ADDRESSEES	: Owners and operators ABC Customer Care and Parts Source
VEHICLE MODEL	: TD925US
MANUAL SECTION	: 14.10 Electricity – wiring
BULLETIN TYPE	: Field Change Program
DATE	: March 23th, 2020
SUBJECT	: To optimize power supply of fuse holder ZB3 in junction box EKA
TERMS & CONDITIONS	: Refer to the warranty section further in this Bulletin.

Figure 1: In luggage compartment, location of concerned 6mm² power supply wire on grid panel of junction box “Vanner”

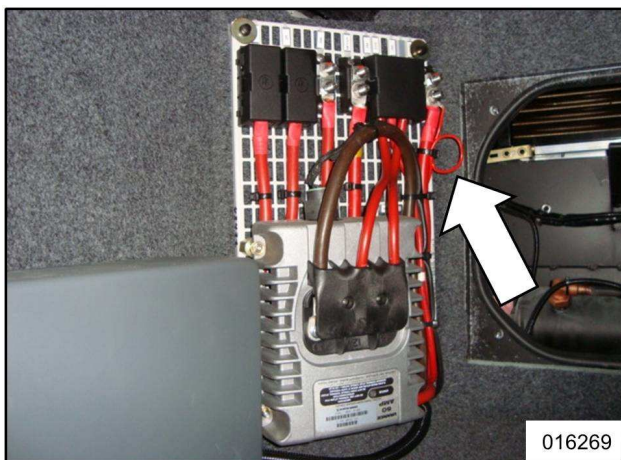
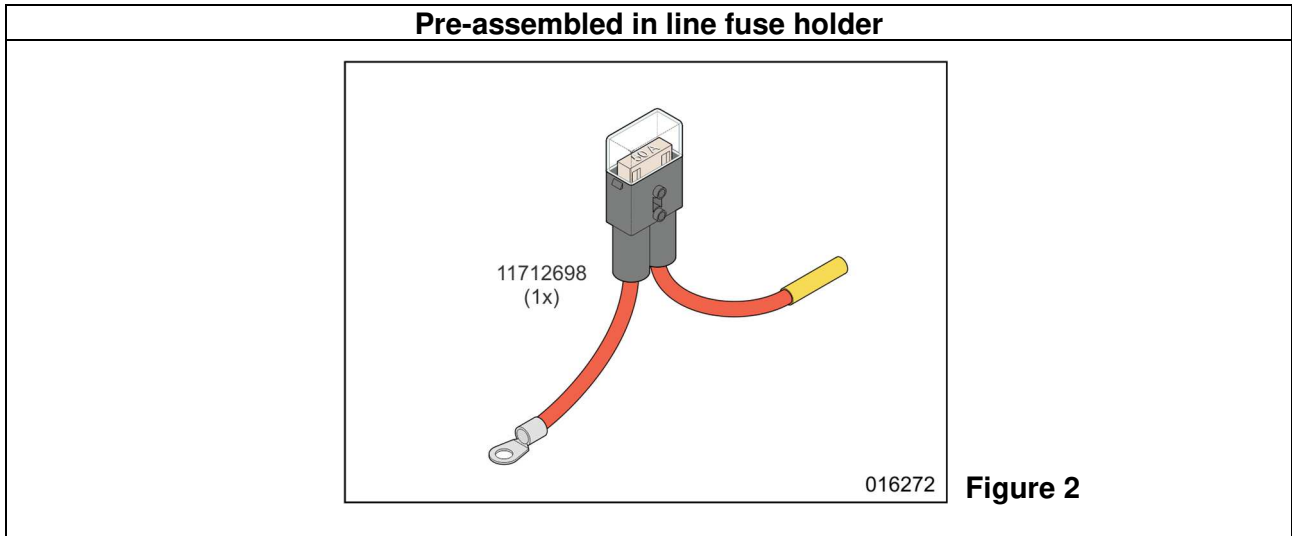
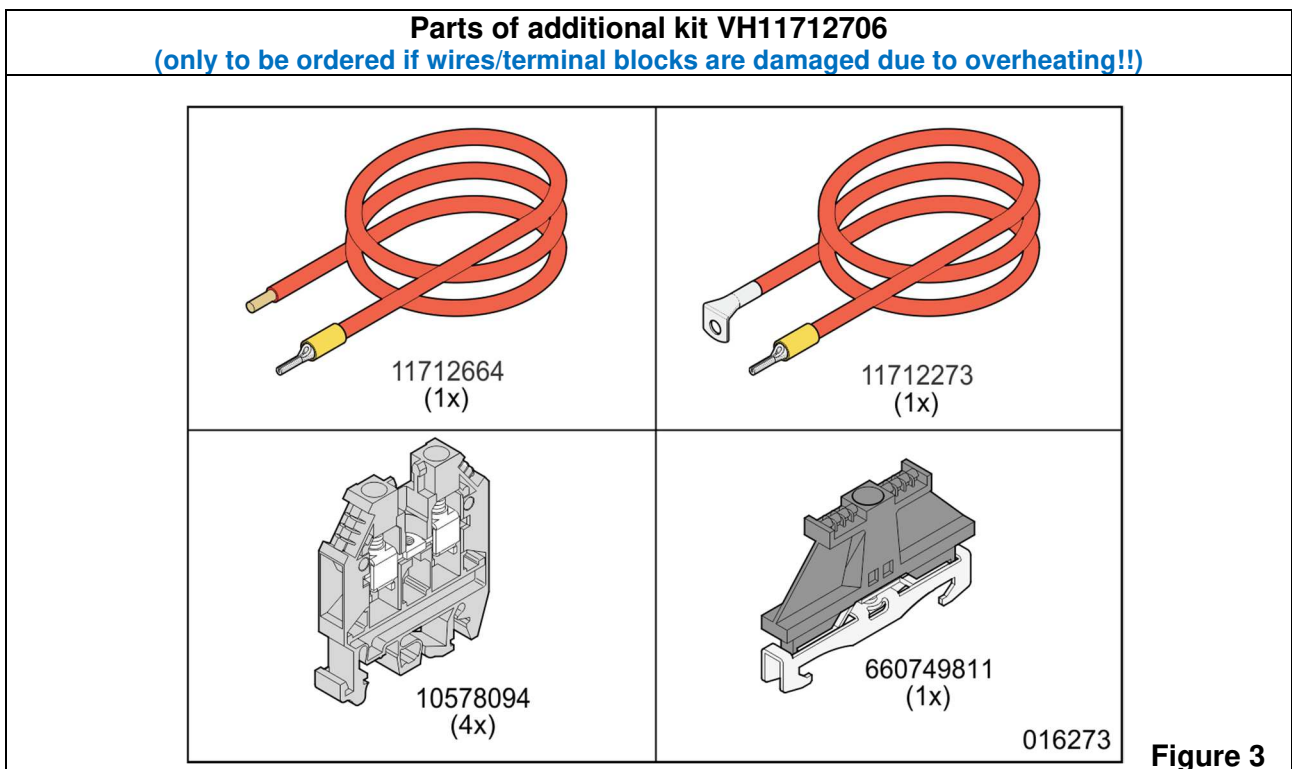
It has been reported that the red 6 mm² power supply wire connected at stud “MP+24V” in junction box “Vanner” is not protected by a fuse. This wire runs from stud “MP+24V” to terminal block DVB in junction box EKA, from there the wire continues to fuse holder ZB3 in junction box EKA to power fuses Z83.1 and Z86.

This service bulletin gives step-by-step instructions how to install an additional 30A in-line fuse in junction box “Vanner” to make sure that this wire is protected against overheating in case of overcurrent.
